32/28 Derne St, Unit 5A Roof Access  
June 15, 2017 - BHAC Submission

**Previously Approved Scheme**  
32/28 Derne St, Unit 5A Roof Access  
June 15, 2017 - BHAC Submission

**Updated Proposal**

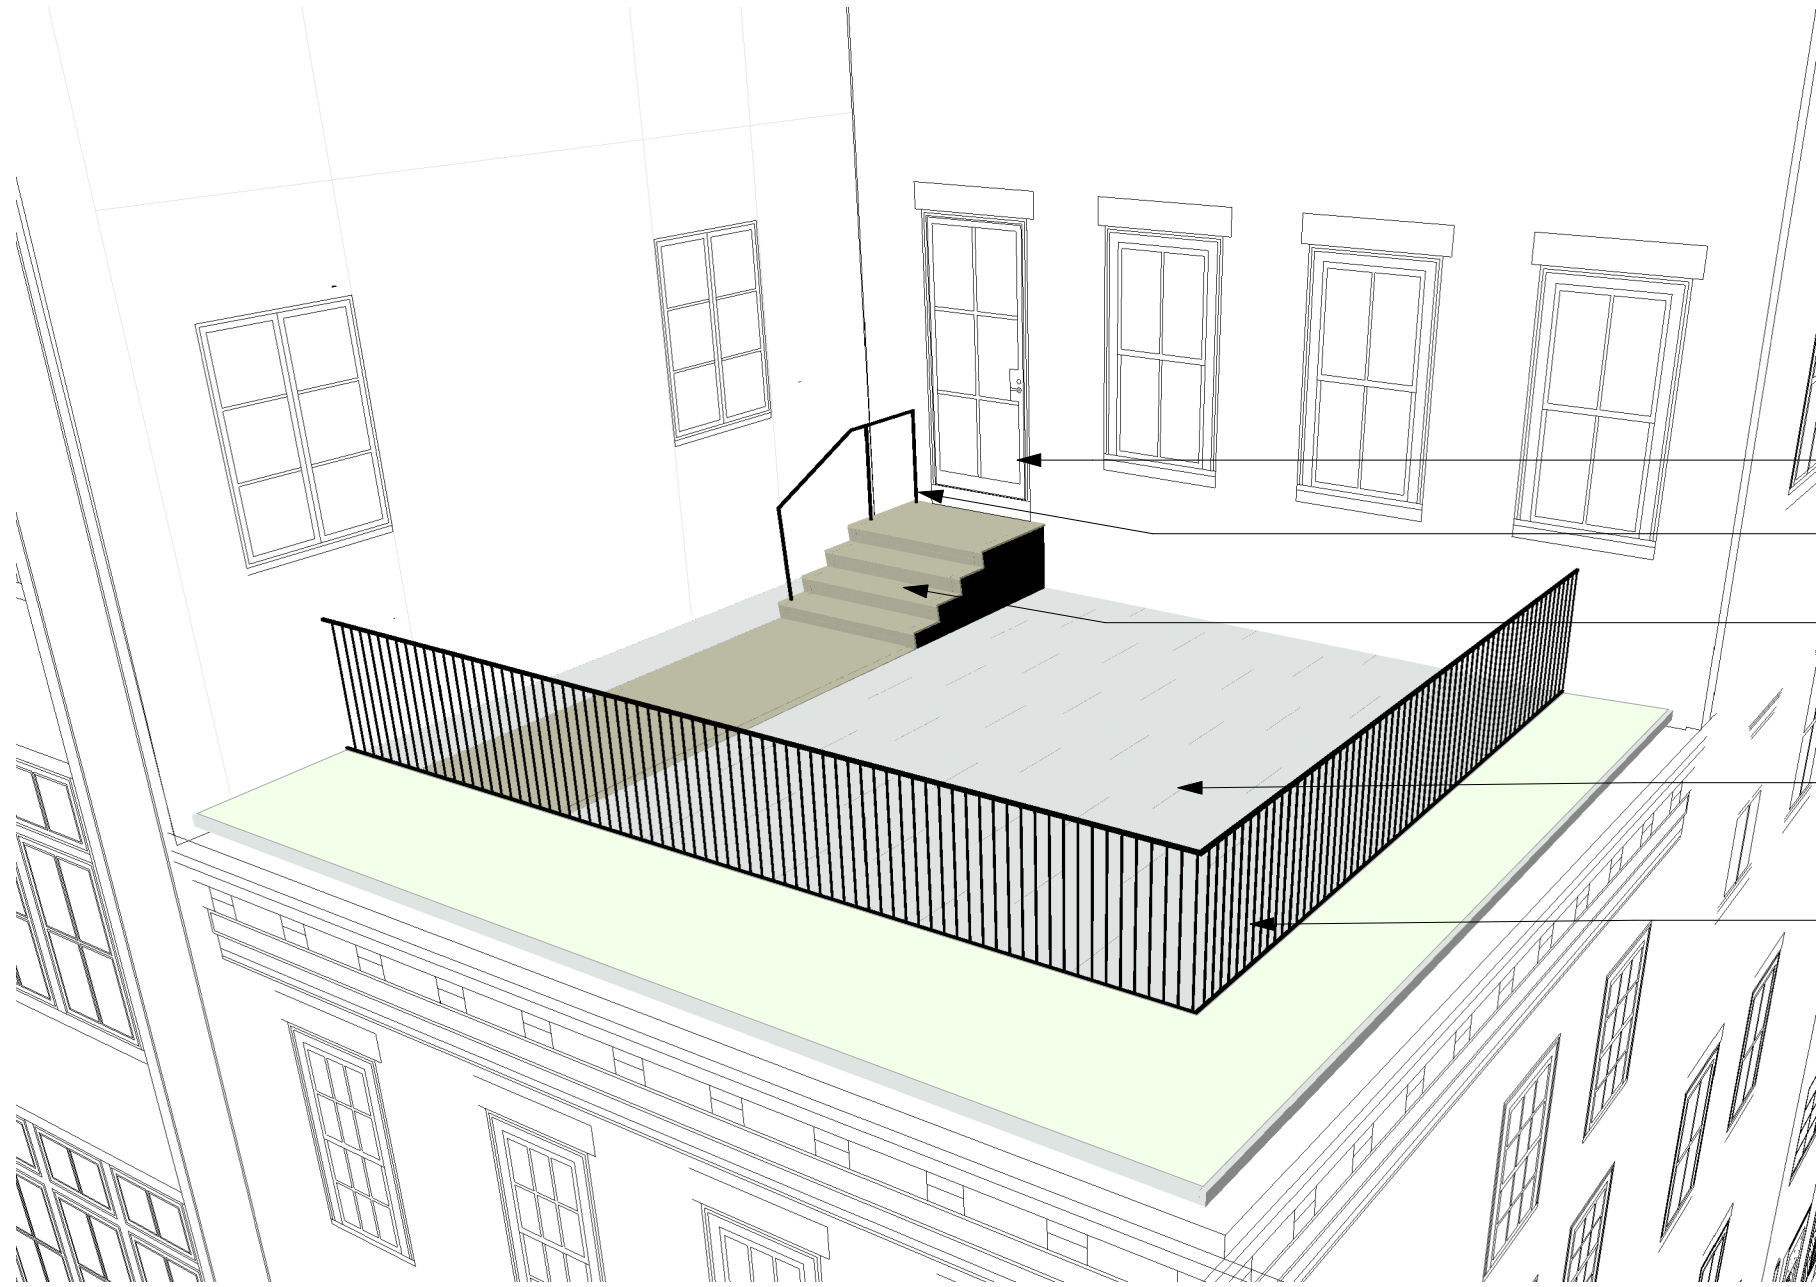
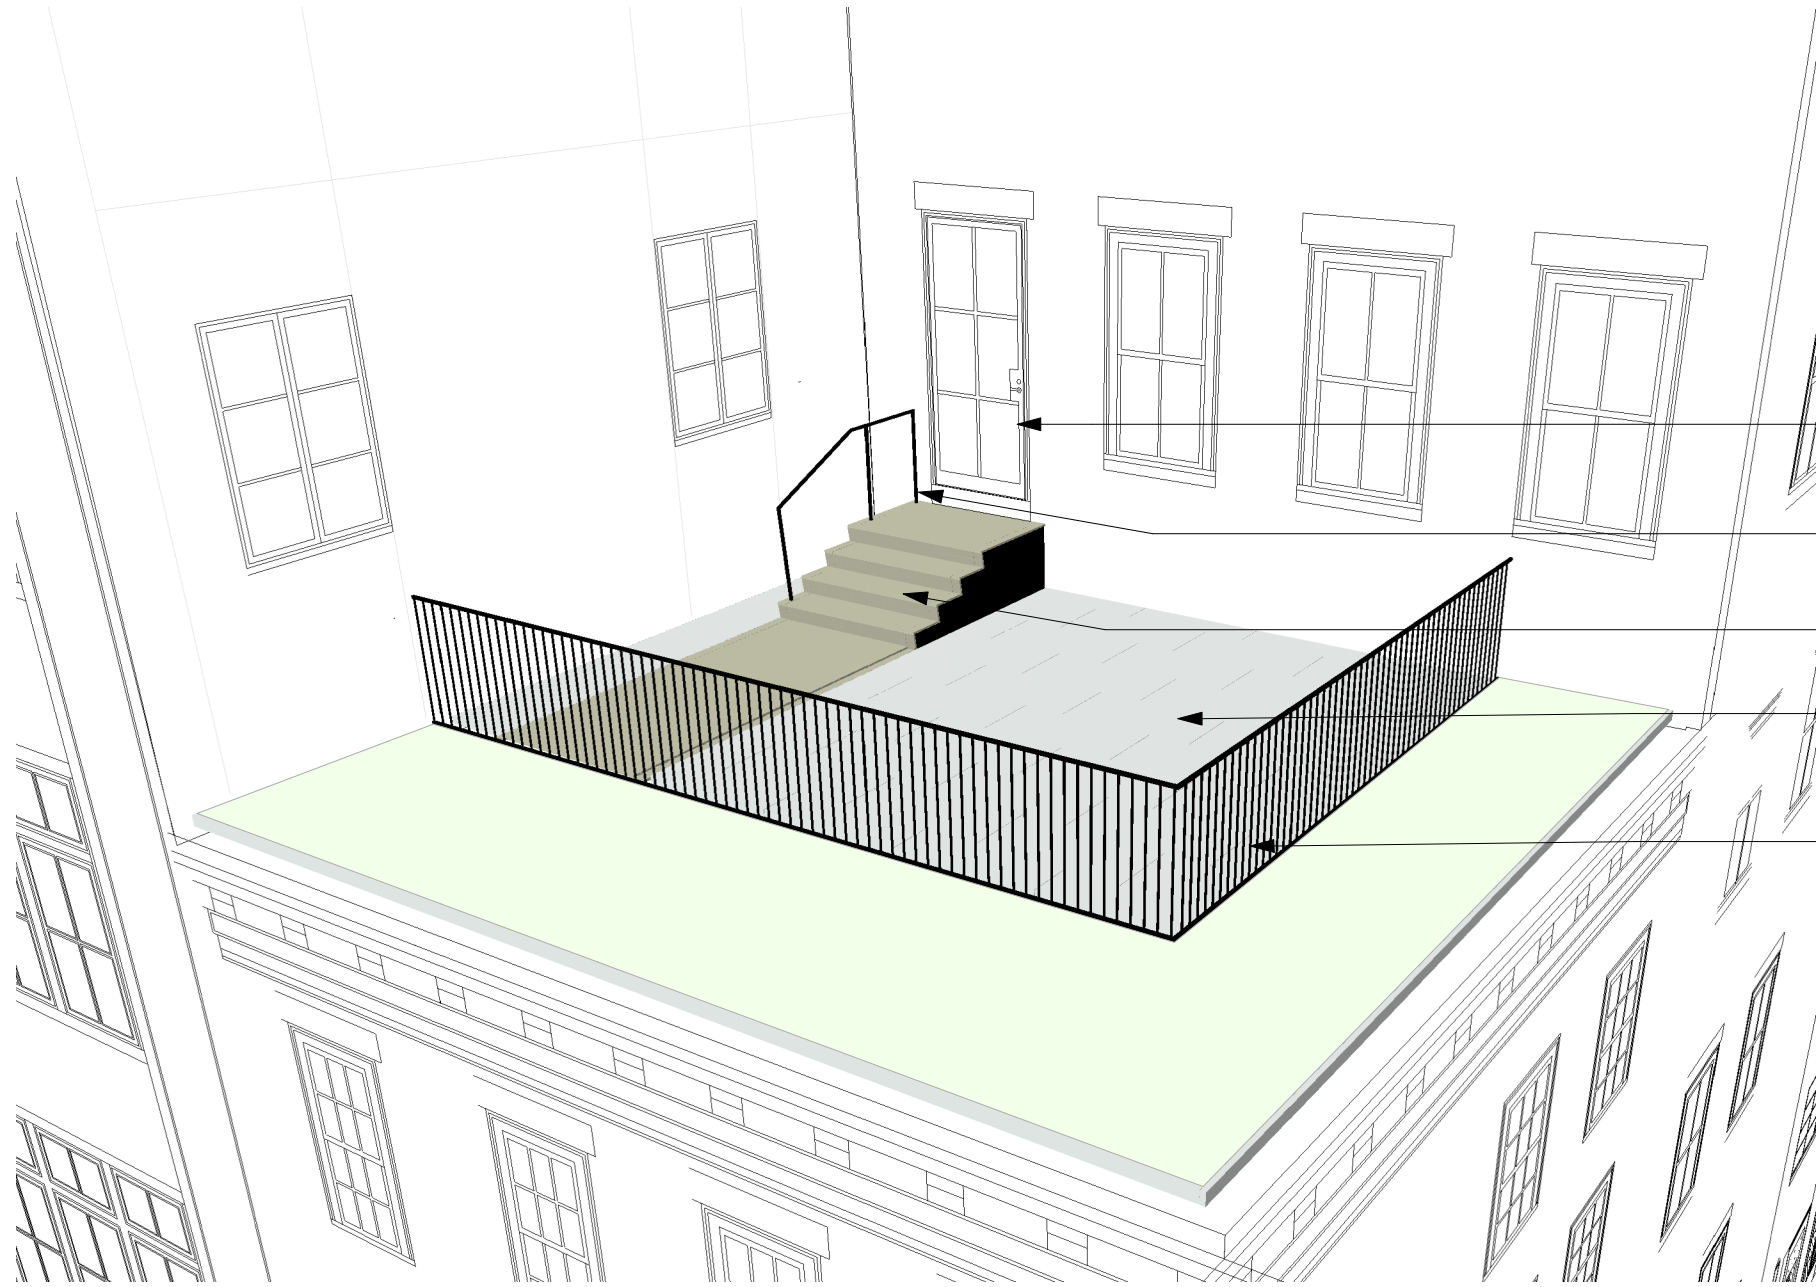
**HANDRAIL:**  
BLACK PAINTED METAL TO MATCH  
SURROUNDING WROUGHT IRON

**GUARDRAIL:**  
BLACK PAINTED METAL GUARDRAIL  
TO MATCH SURROUNDING  
WROUGHT IRON

**Proposed Guardrail Detail**

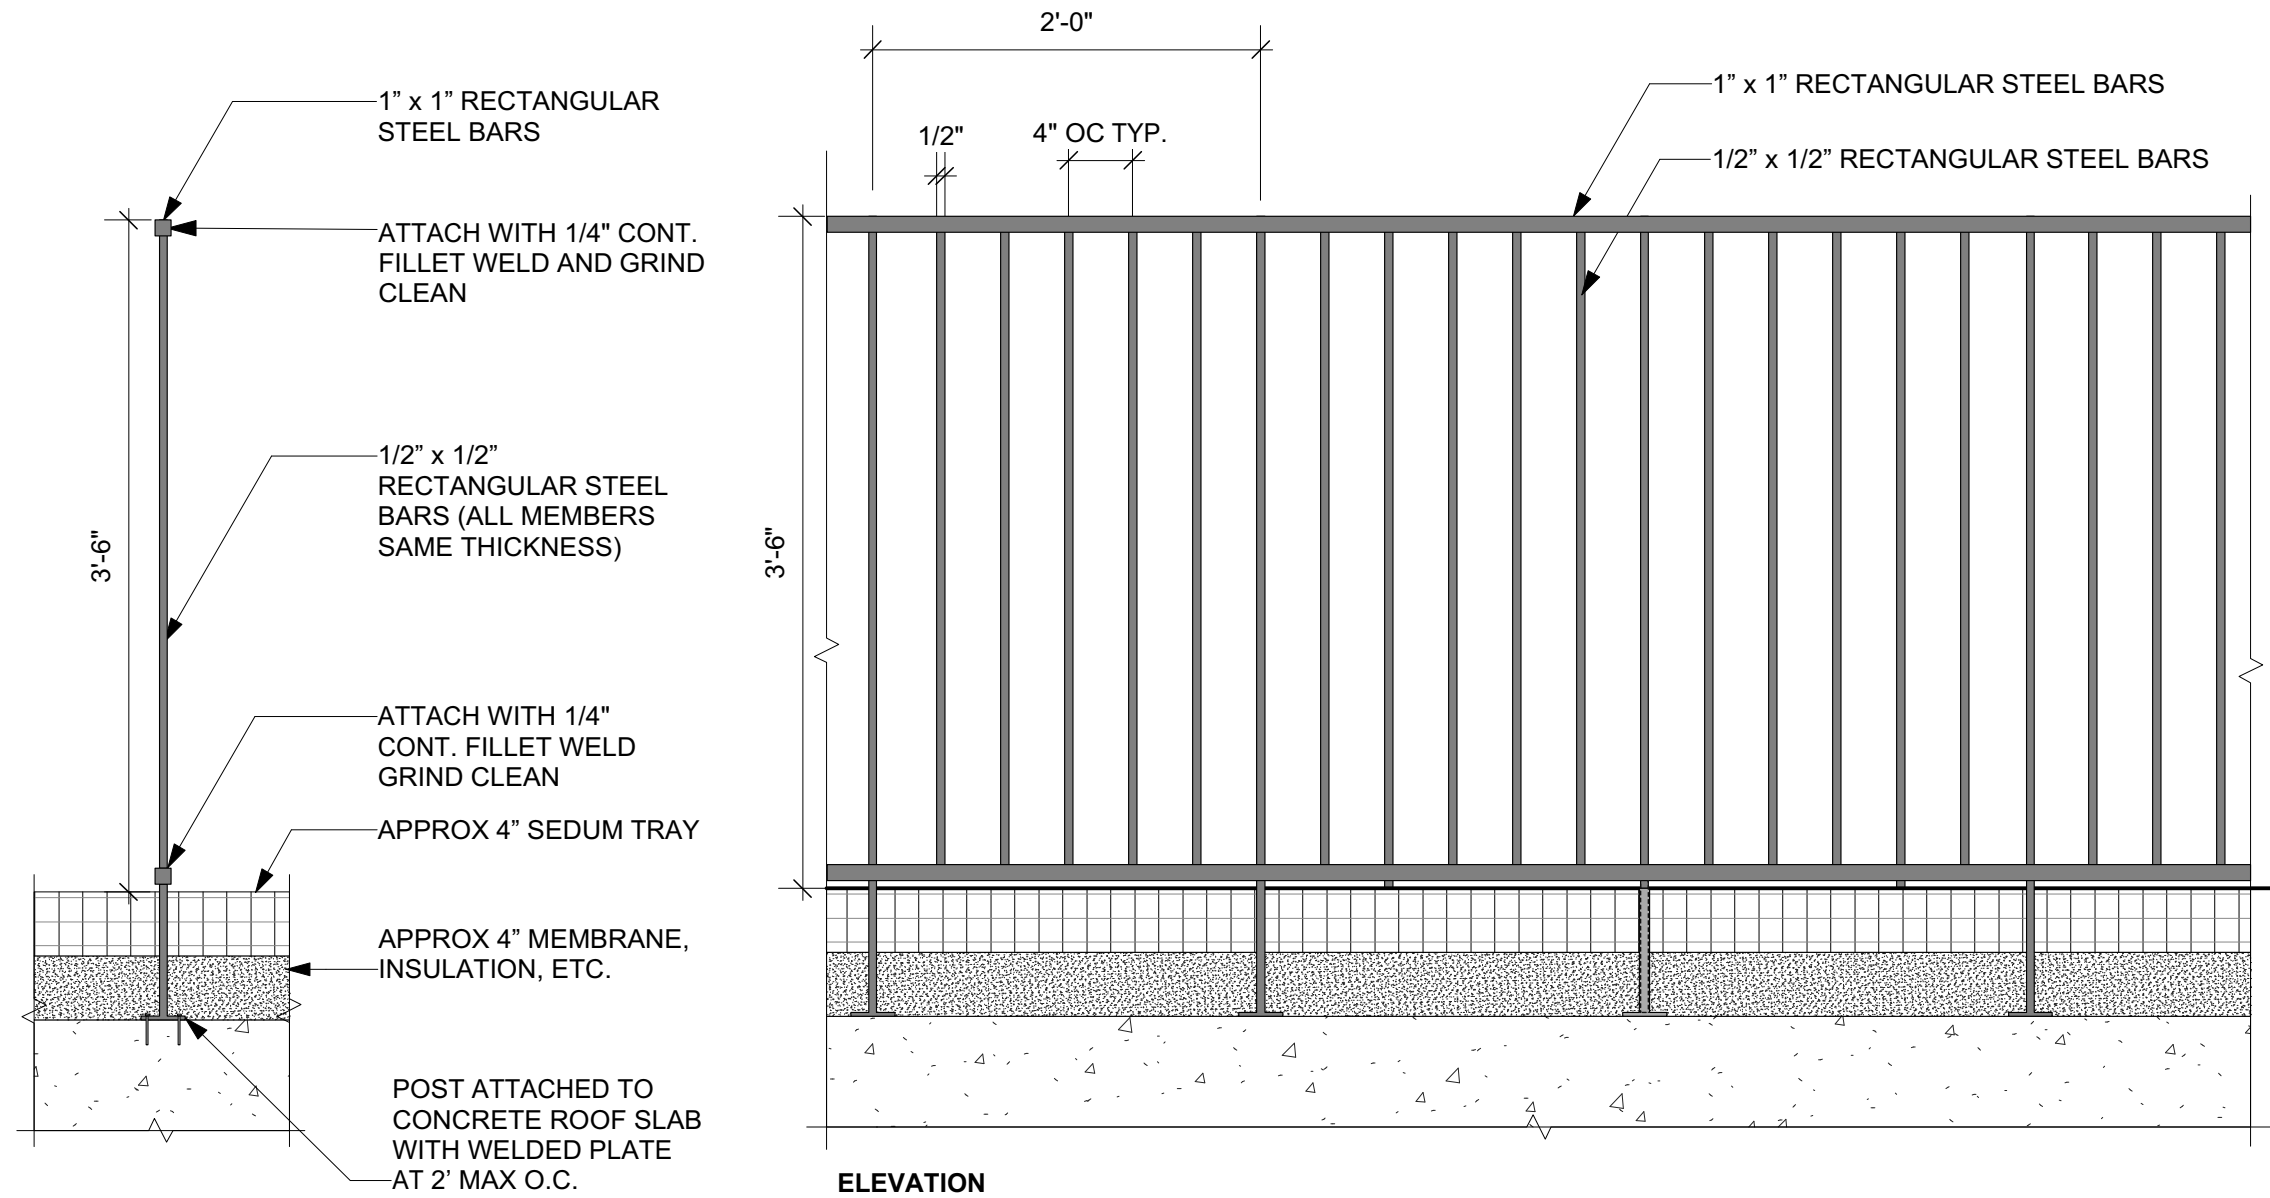
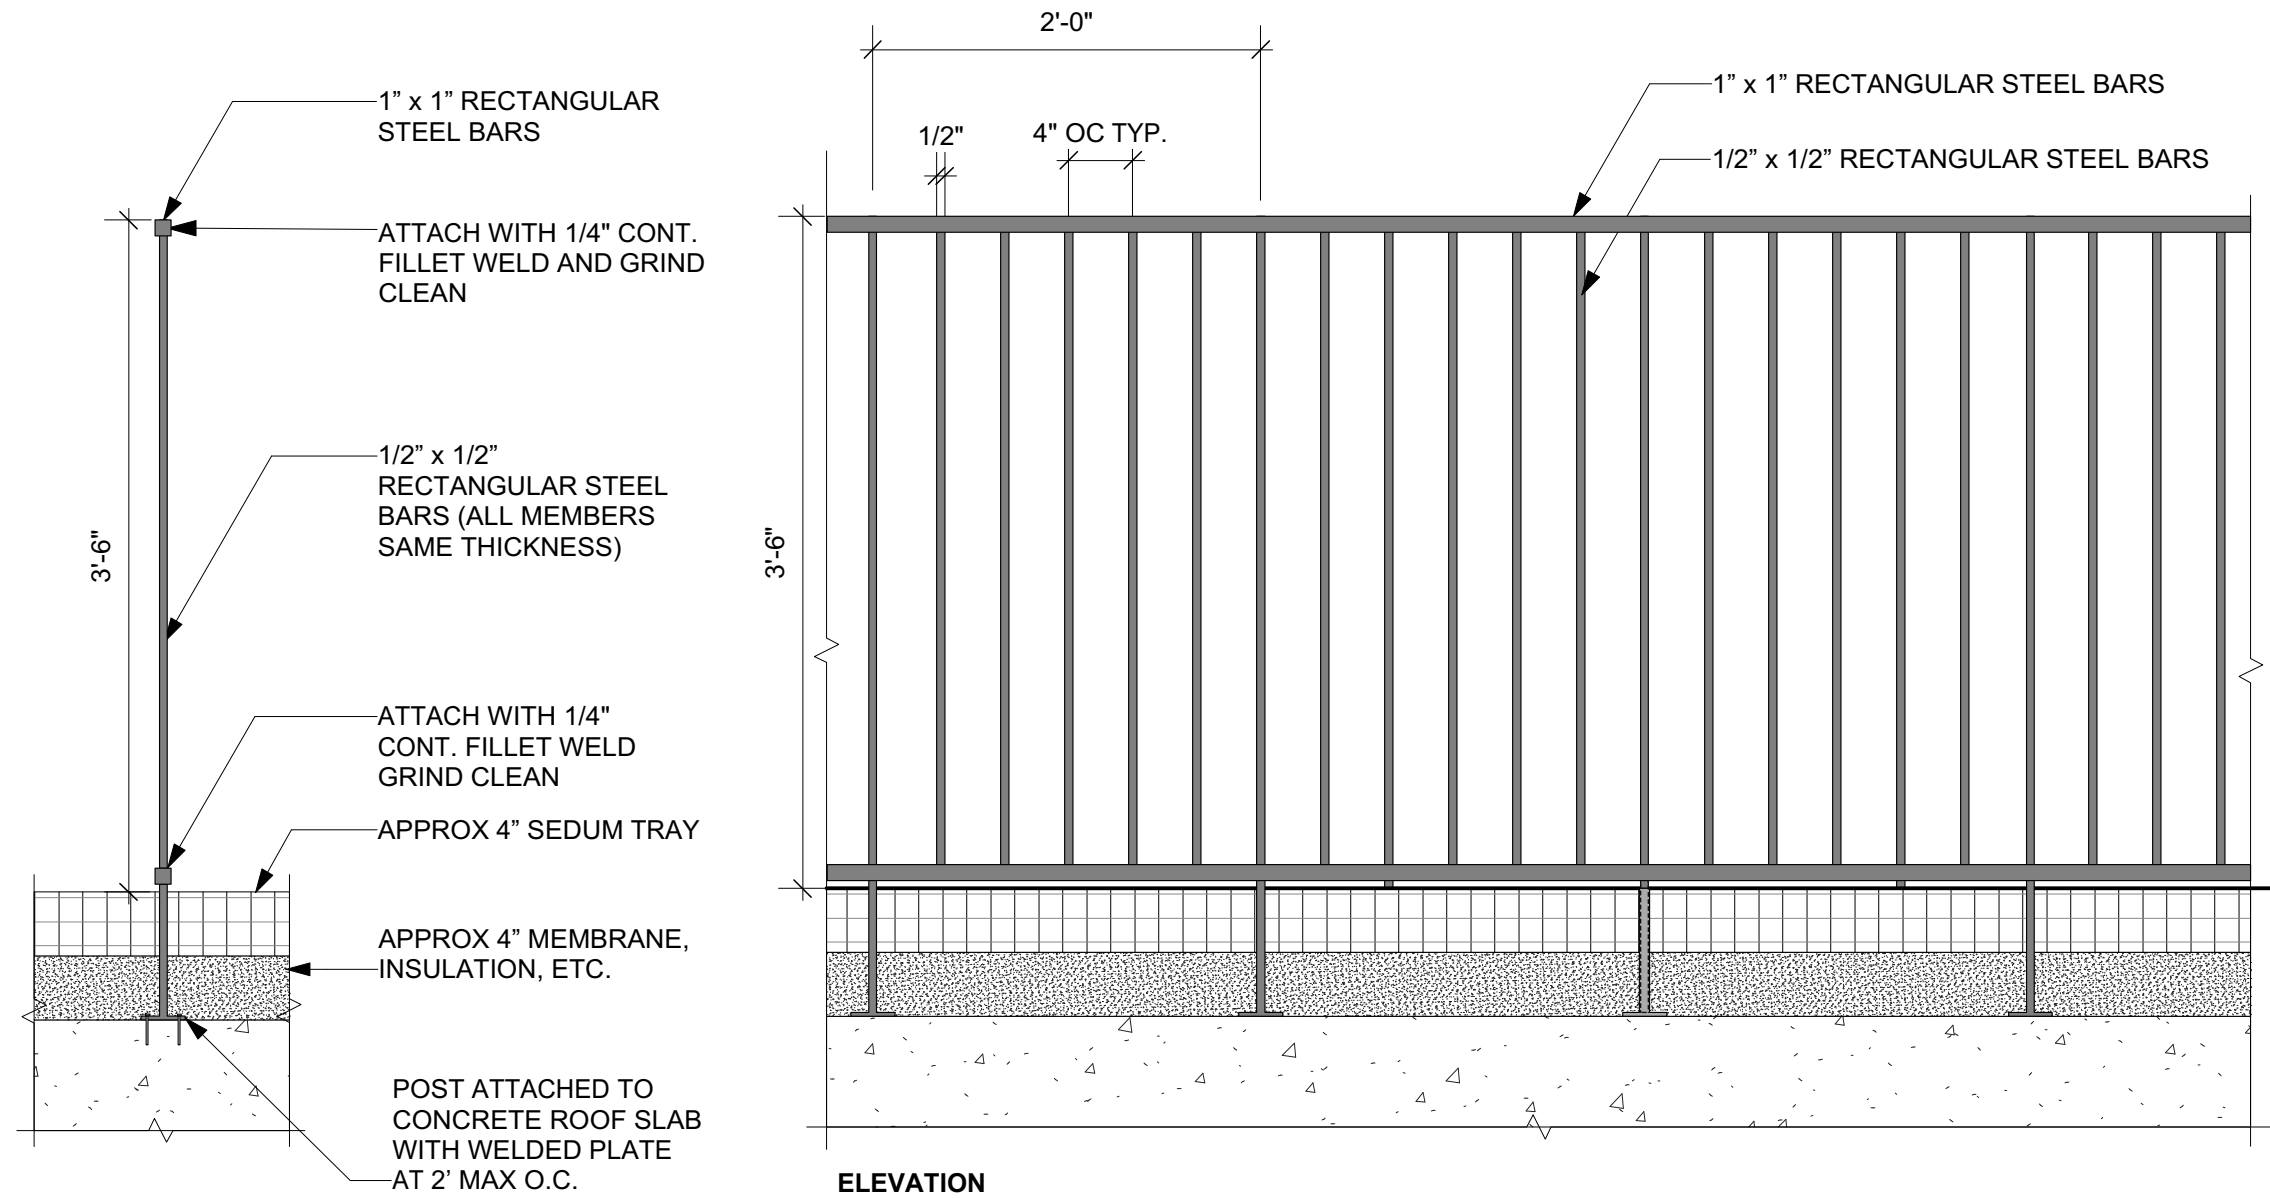
Black painted metal to match surrounding wrought iron

**Section 1015.3, Exception #1:**  
Guards within an individual dwelling unit of a R-2  
occupancy may be, not less than 36" in height  
if not more than three stories above grade.
